13. **Project# 1007778**
09DRB-70274 SKETCH PLAT REVIEW
AND COMMENT

RICHARD R. WAGNER request(s) the above action(s) for all or a portion of Lot(s) 1, Block(s) 60, **UNIVERSITY HEIGHTS ADDITION**, zoned R-1, located on 502 BRYN MAWR DR SE BETWEEN GARFIELD SE AND BURTON SE containing approximately 0.124 acre(s). (K-16)

DRB Comments

RE: Lot 1, Block 60, University Heights Addition

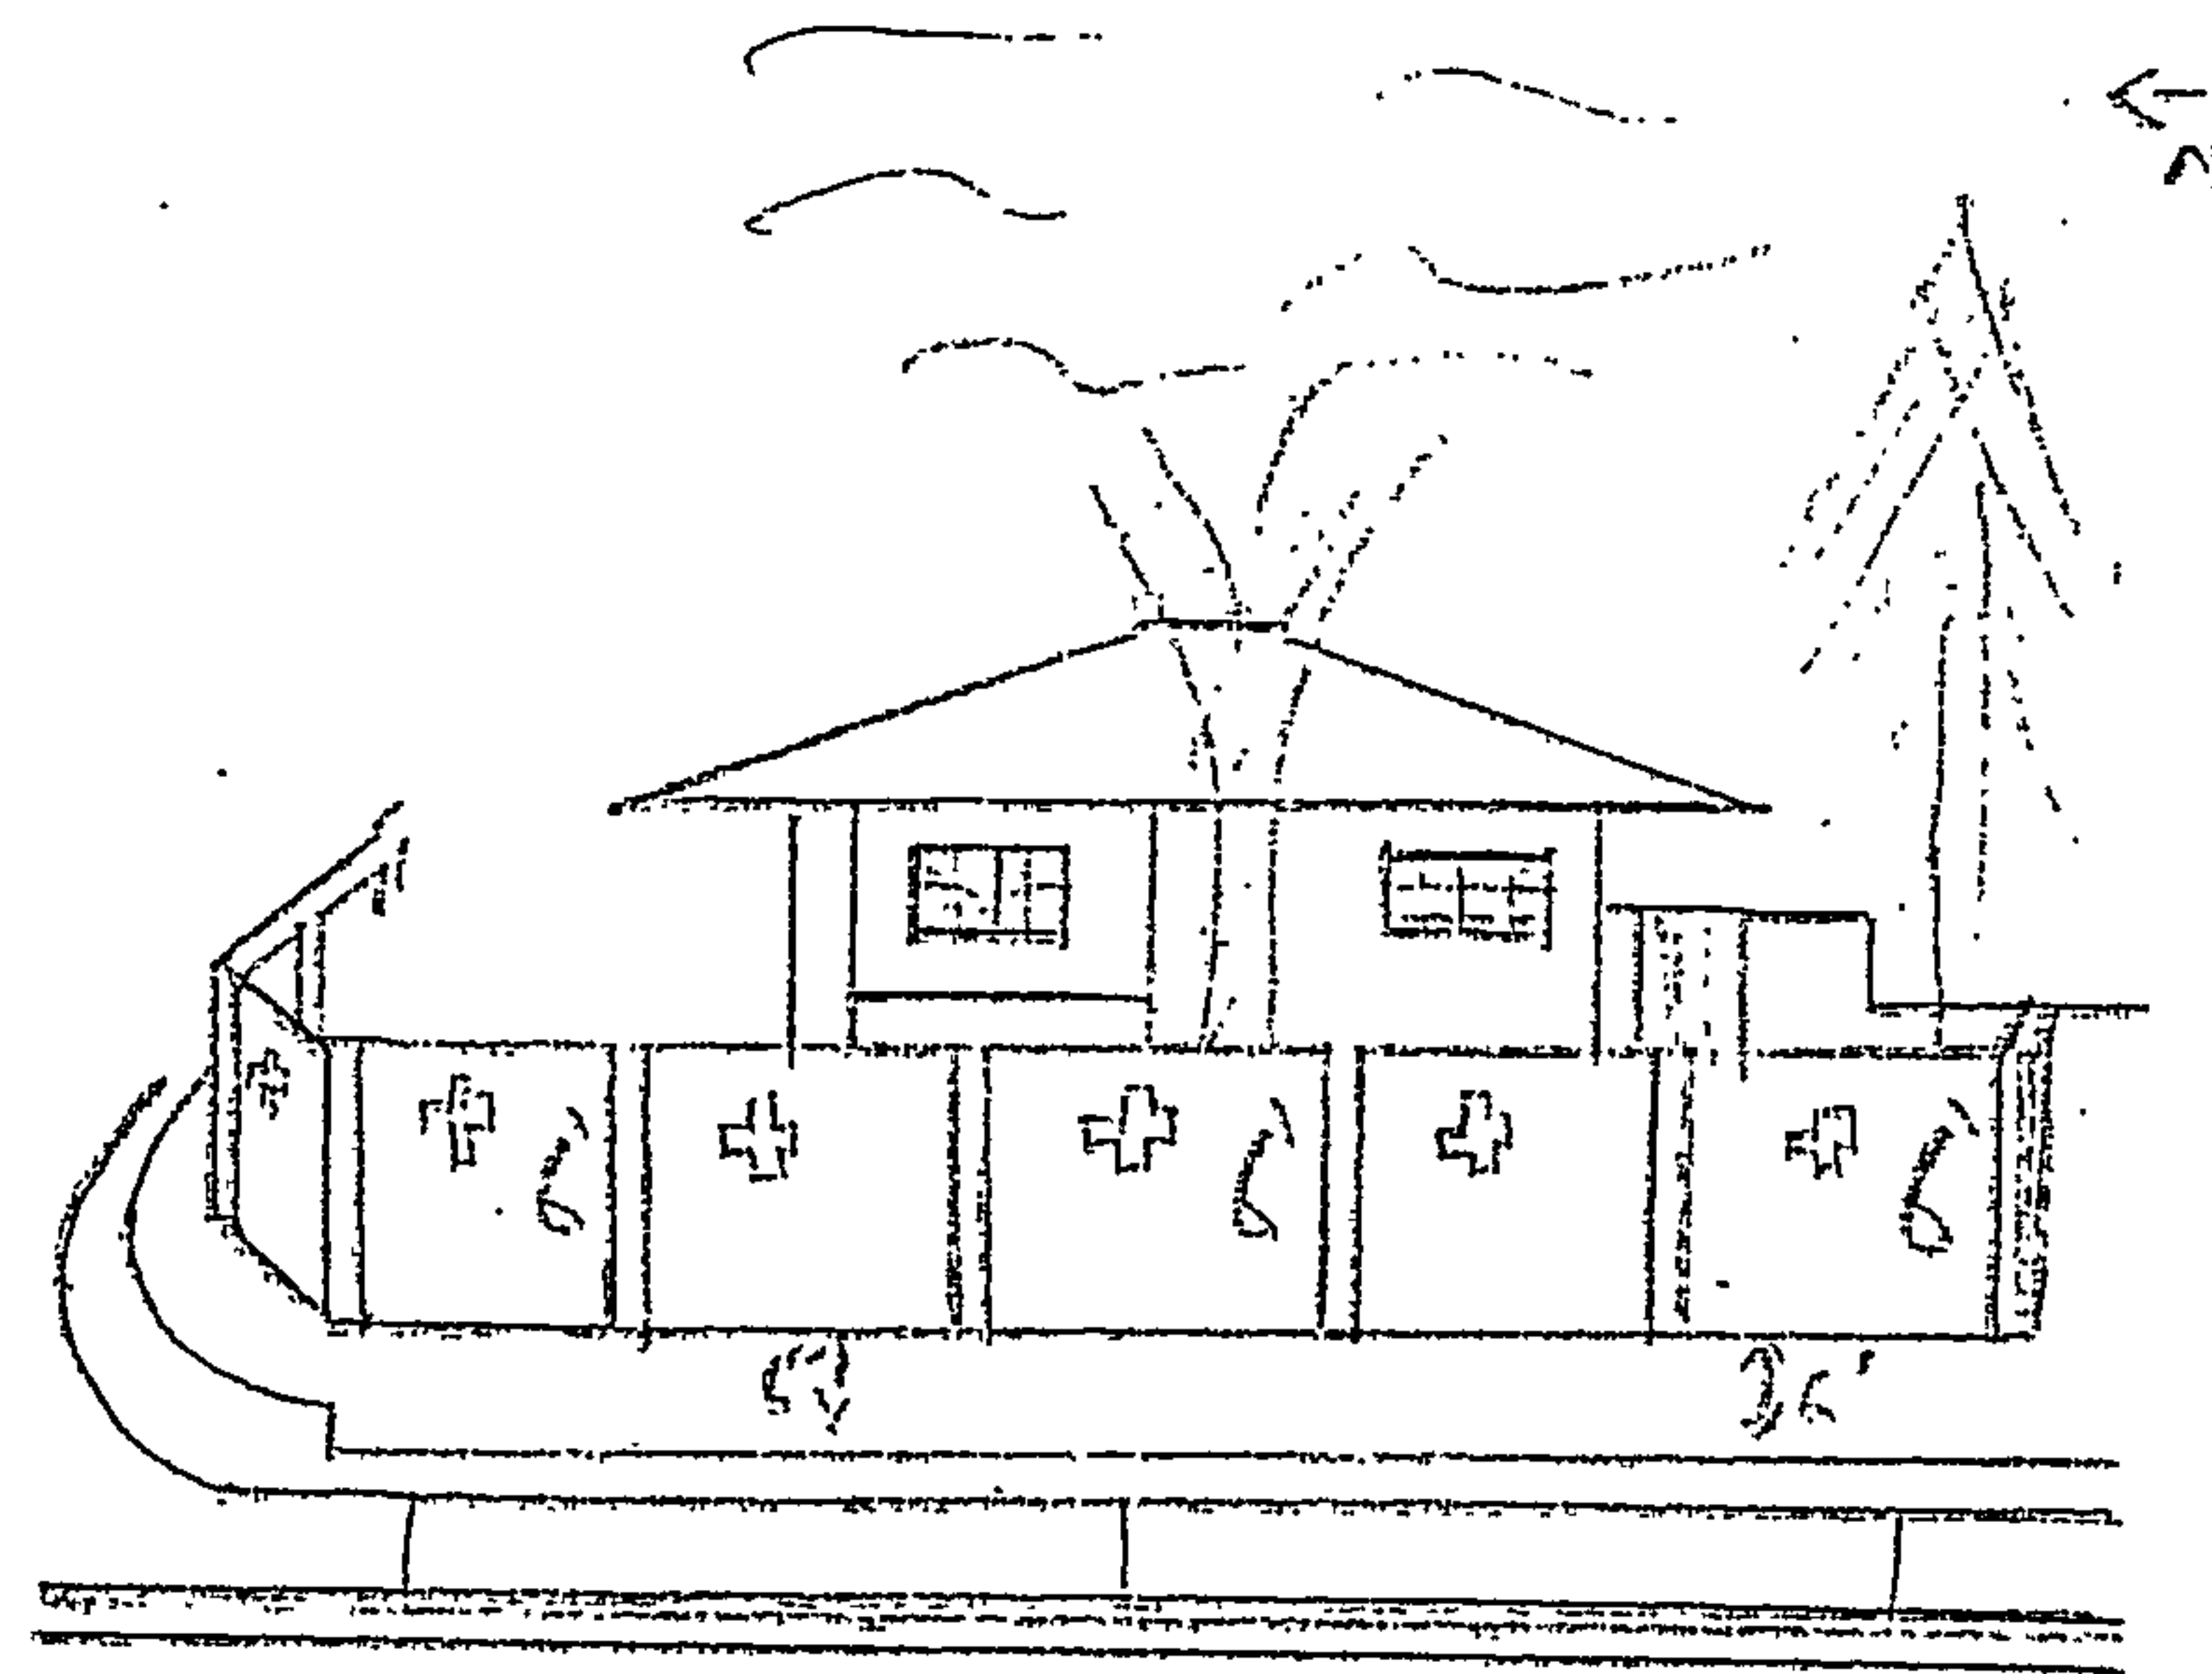
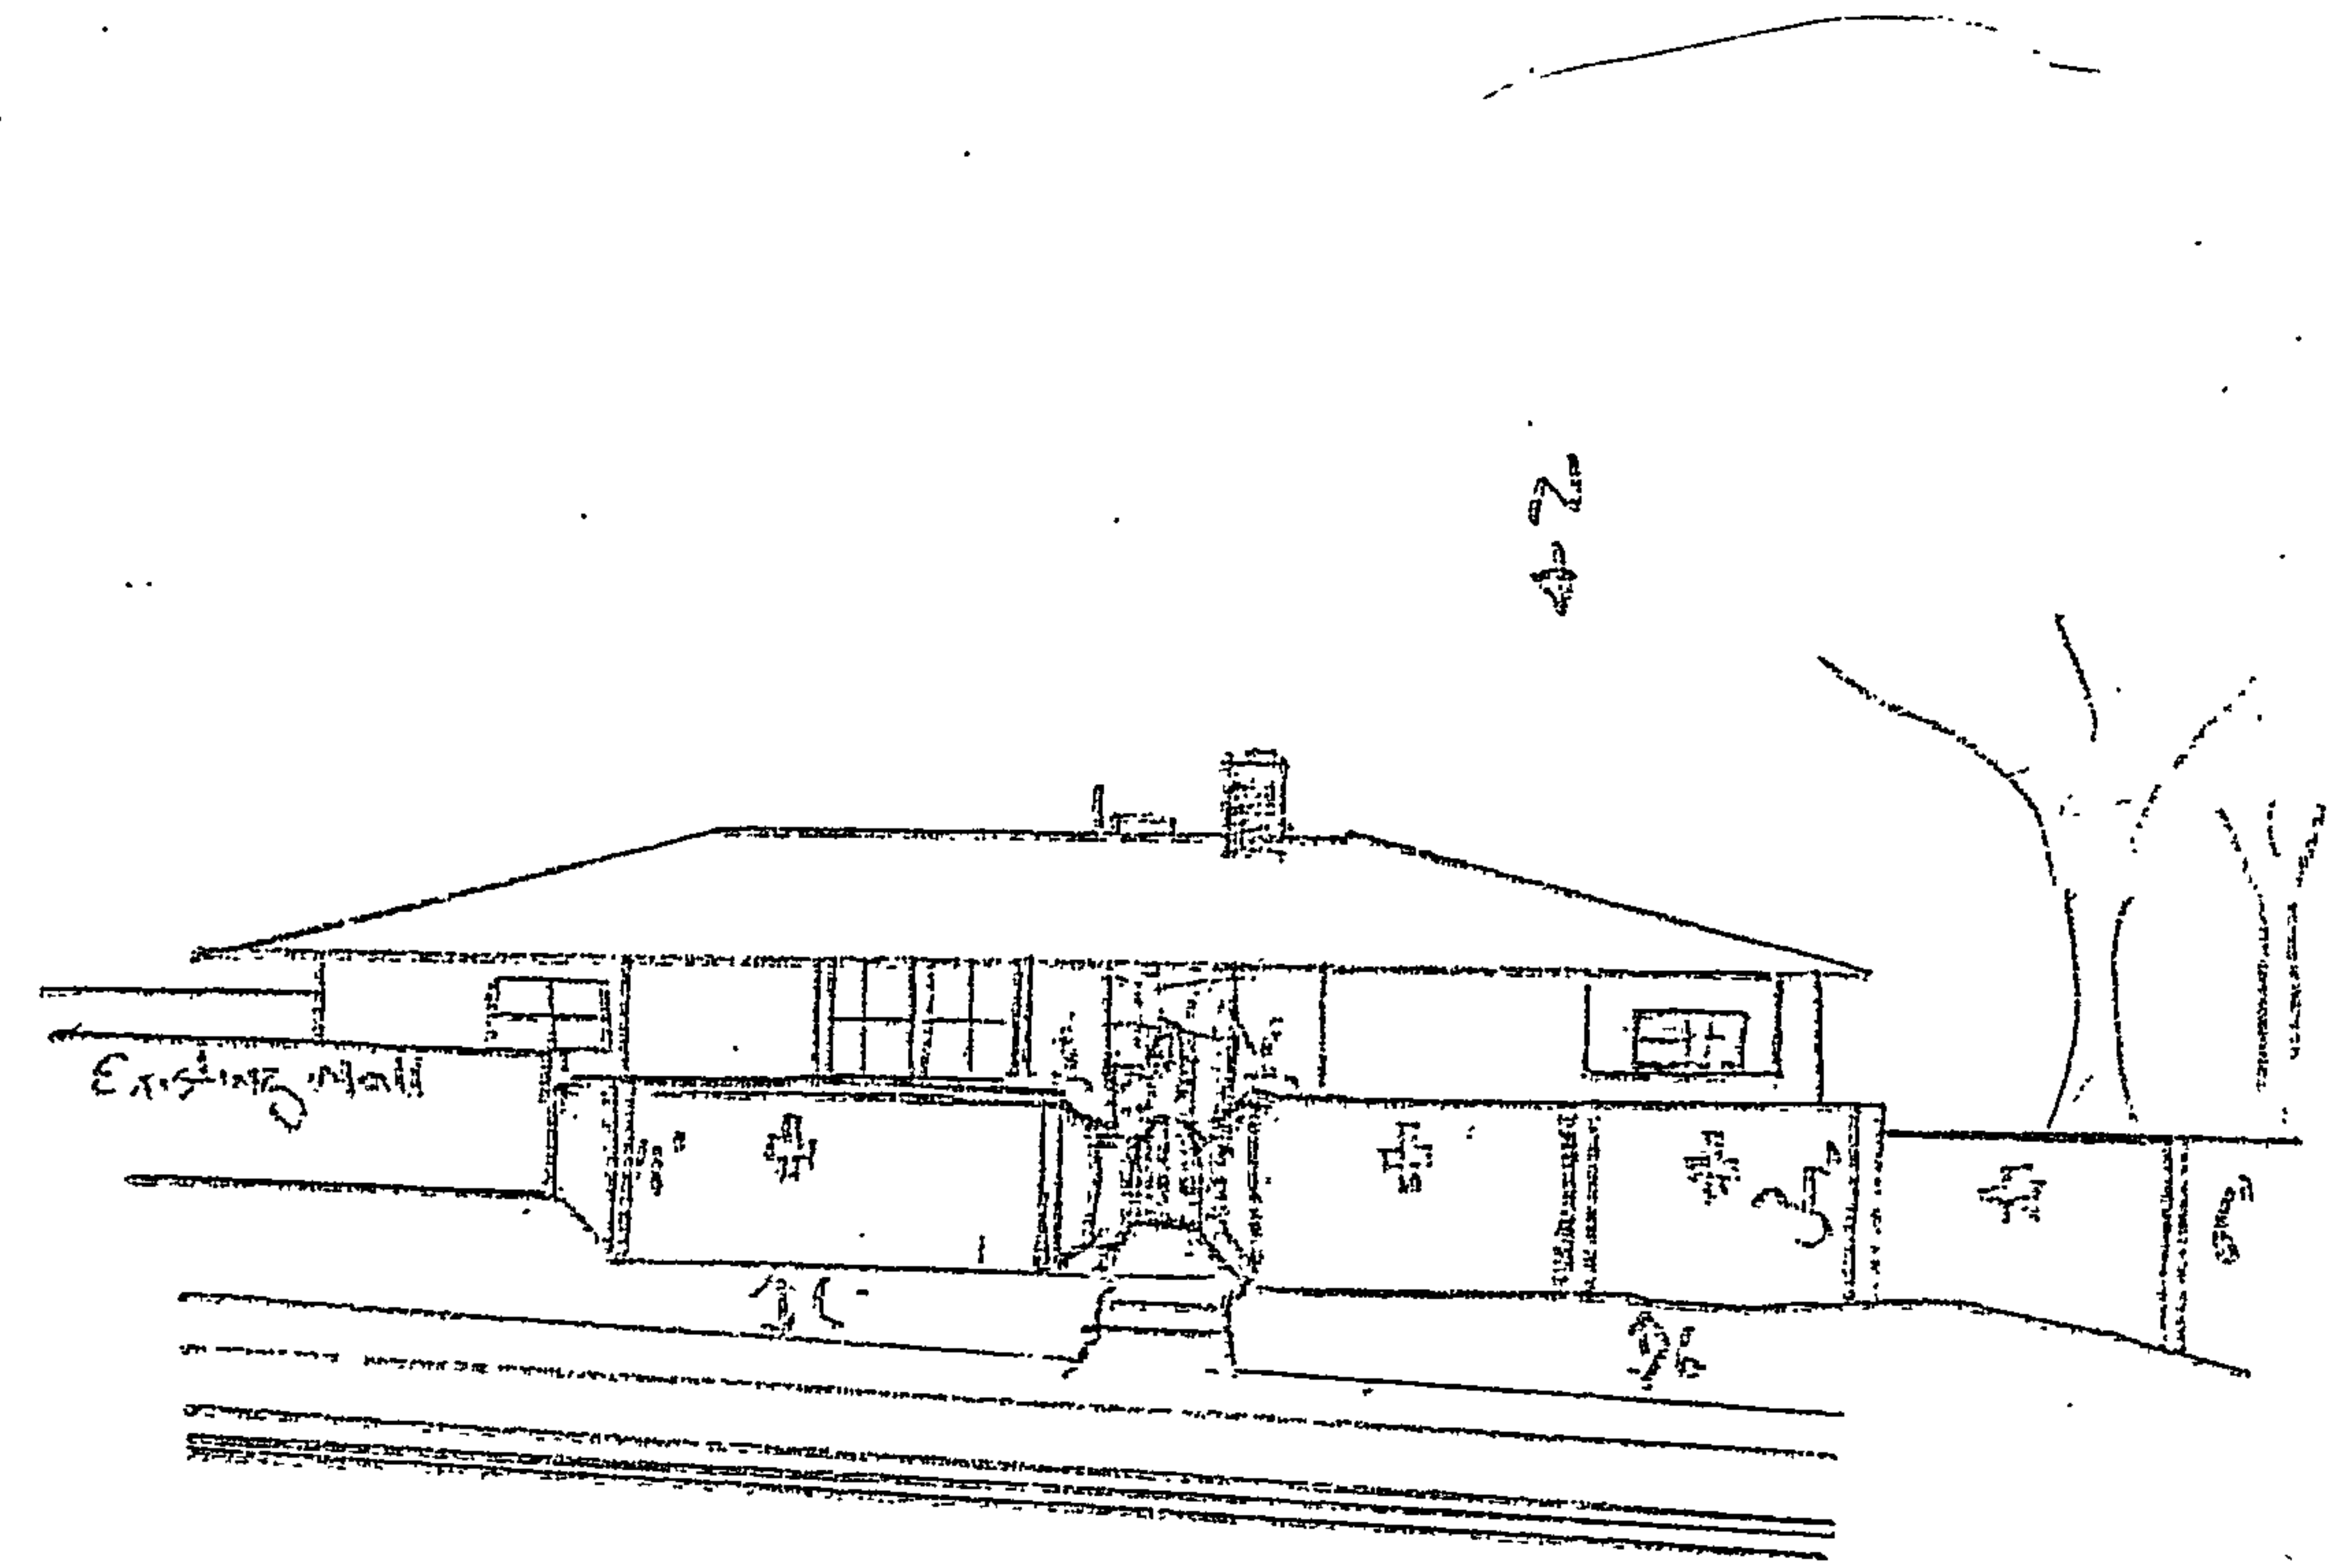
Refer to comments from Transportation Development – typically the City must retain 9 feet of right-of-way behind the curb of the street, and intersection corners must remain clear to allow visibility of cross traffic. On the City's Geographic Information System (GIS) it appears that the right-of-way width for Garfield is only 55 feet for this block and the block to the east.

Vacation of public right-of-way will require an advertised public hearing; if approved, the acquisition of the vacated right-of-way would need to be negotiated with the City's Real Property Division and replatted within one year.

Contact Zoning Enforcement regarding proposed wall – it appears a Conditional Use Permit would be required for a wall greater than 3 feet in height at the proposed location.
